SECTION 009113 – ADDENDUM TWO

- A. Project Name: 22034.08 Meridian High School Parking and Site.
- B. Owner: Meridian Public School District, 1019 25th Avenue, Meridian, MS 38391
- C. Architect: Dale | Bailey, an Association, One Jackson Place, Suite 250, 188 East Capitol Street, Jackson, MS 39201-2100
- D. Architect Project Number: 22034.02
- E. Date of Addendum Two: 14 March 2024

C-100
Demolition Plan

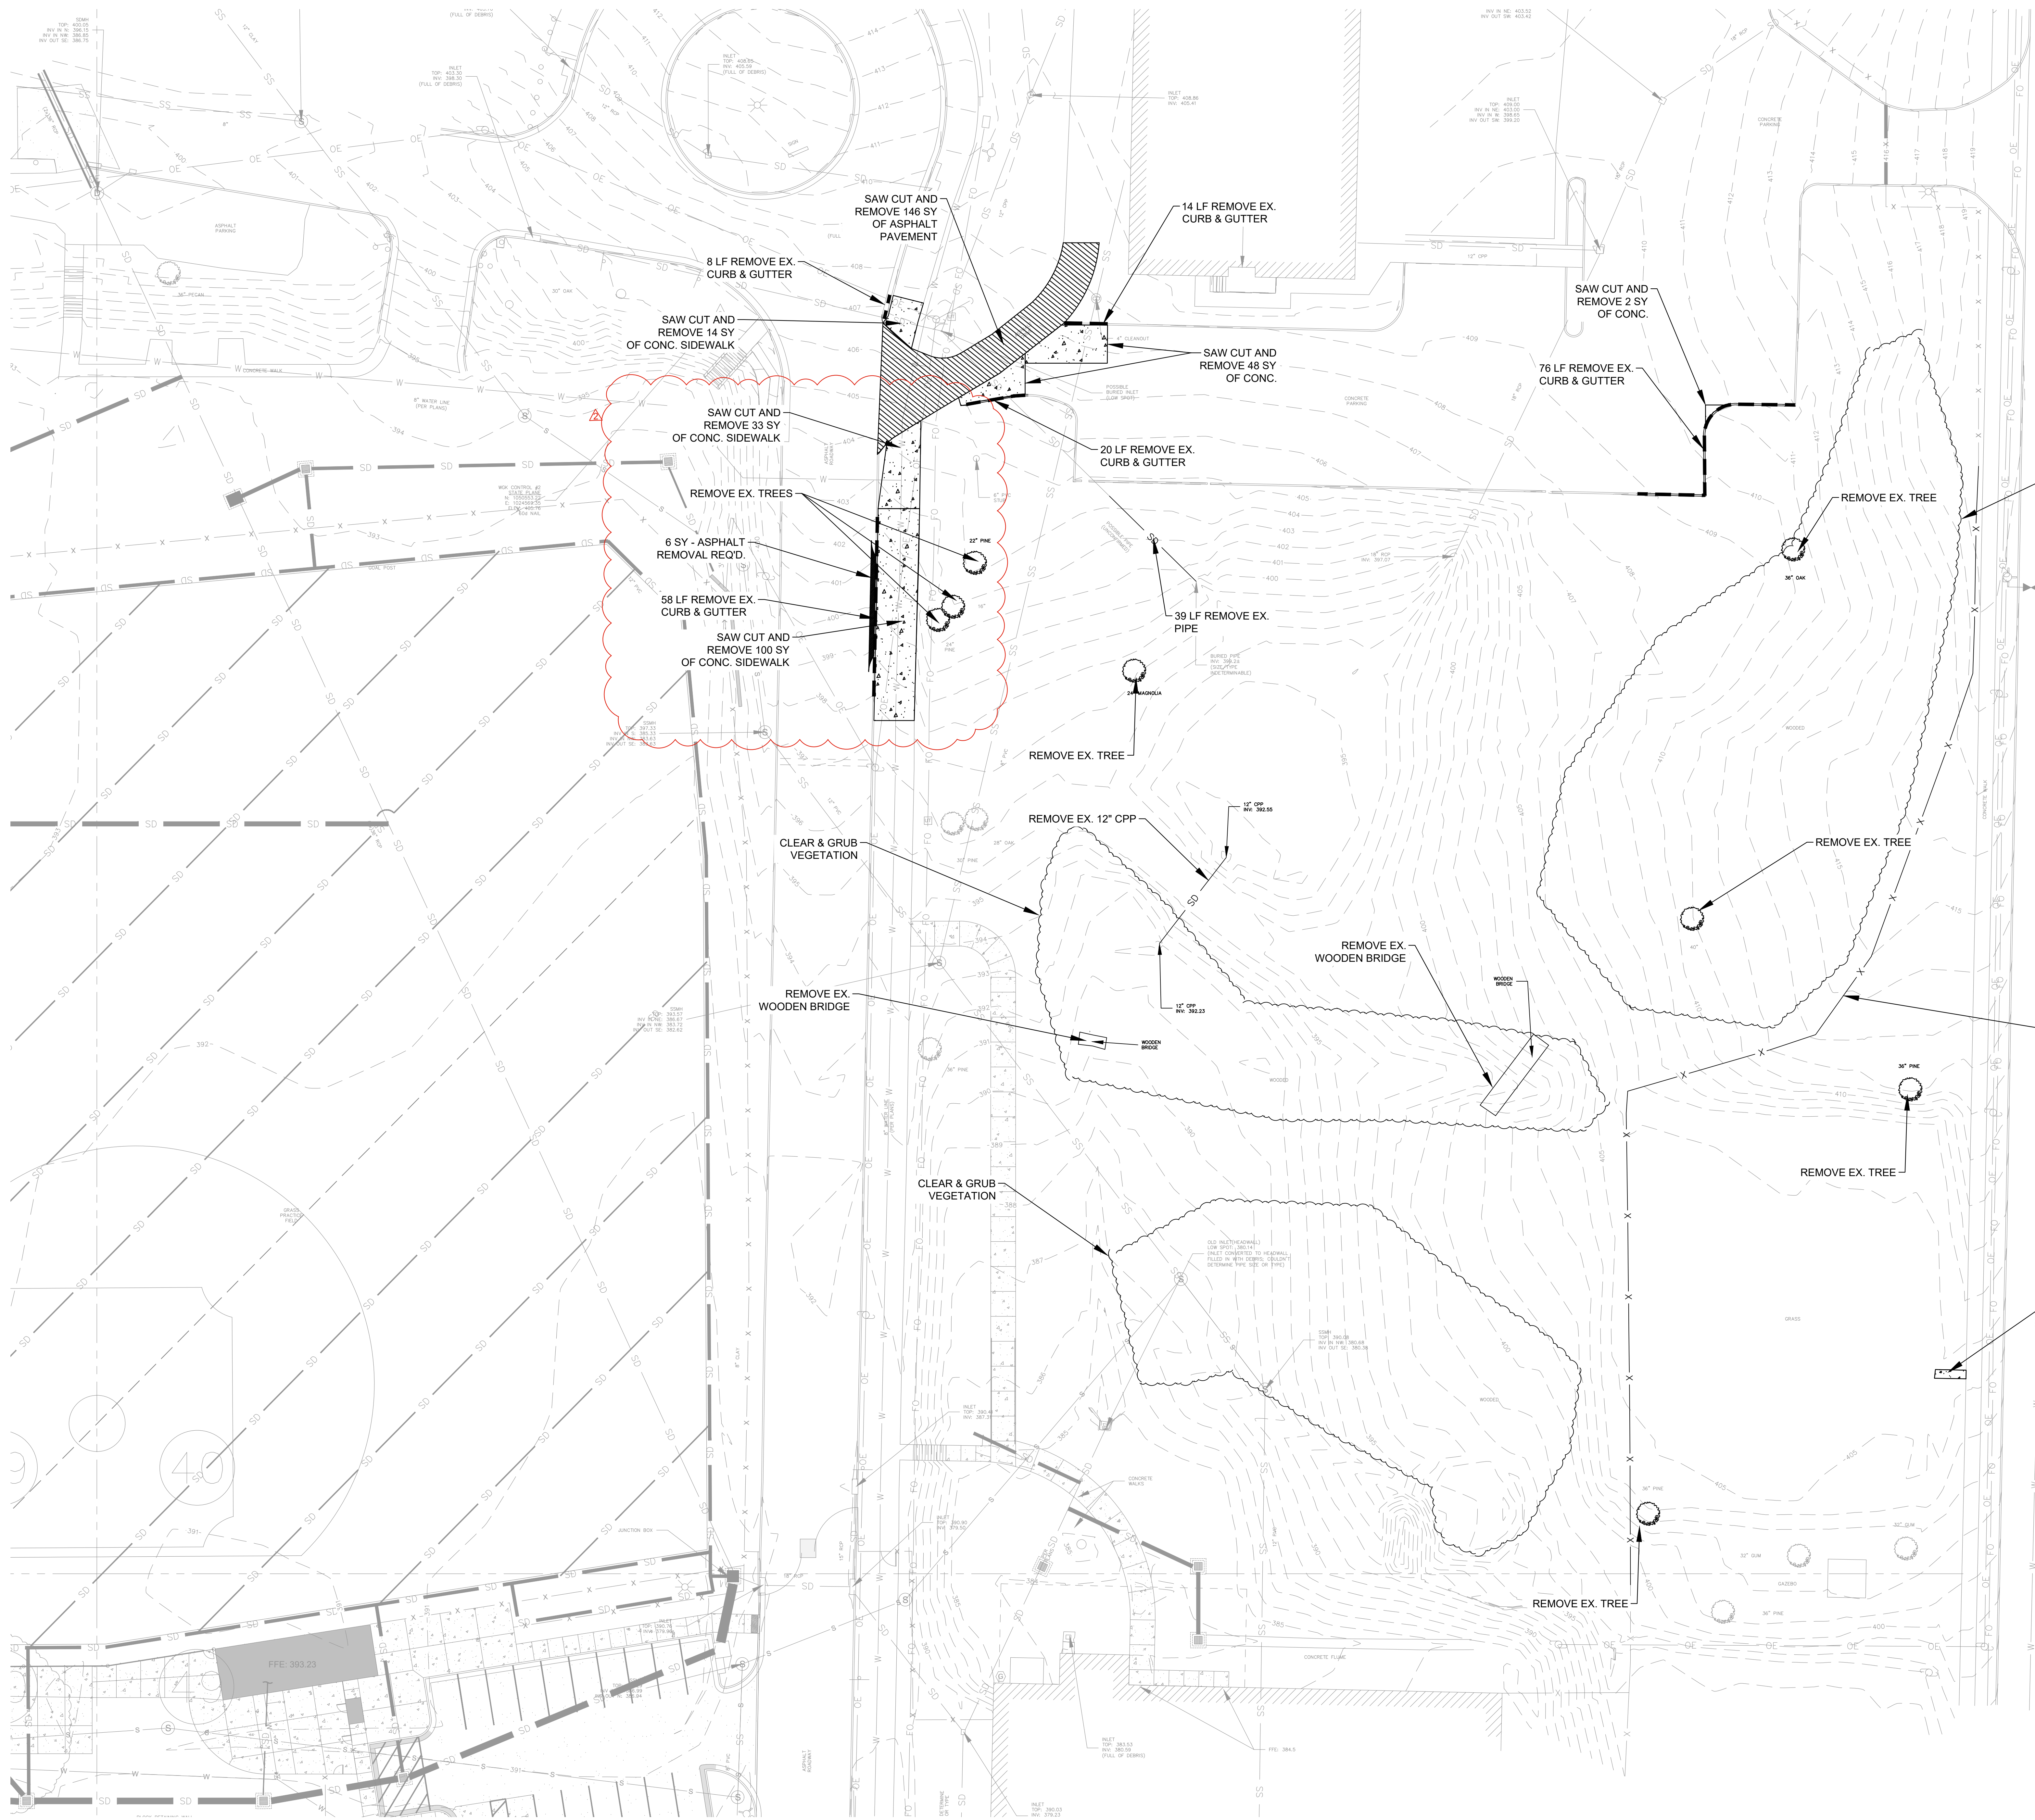
- A. Sheet C-100 – Demolition Plan (Revised). Delete this sheet in its entirety and replace it with the attached. Added additional sidewalk/asphalt demo.
- B. Sheet C-200 – Grading & Drainage Plan (Revised). Delete this sheet in its entirety and replace it with the attached. Revised grading in highlighted area.
- C. Sheet C-300 – Site Plan (Revised). Delete this sheet in its entirety and replace it with the attached. Revised detectable warning panel location, added additional sidewalk, changed color of crosswalk striping.
- D. Sheet C-400 – Joint Layout Plan (Revised). Delete this sheet in its entirety and replace it with the attached. Revised joint layout in highlighted area.
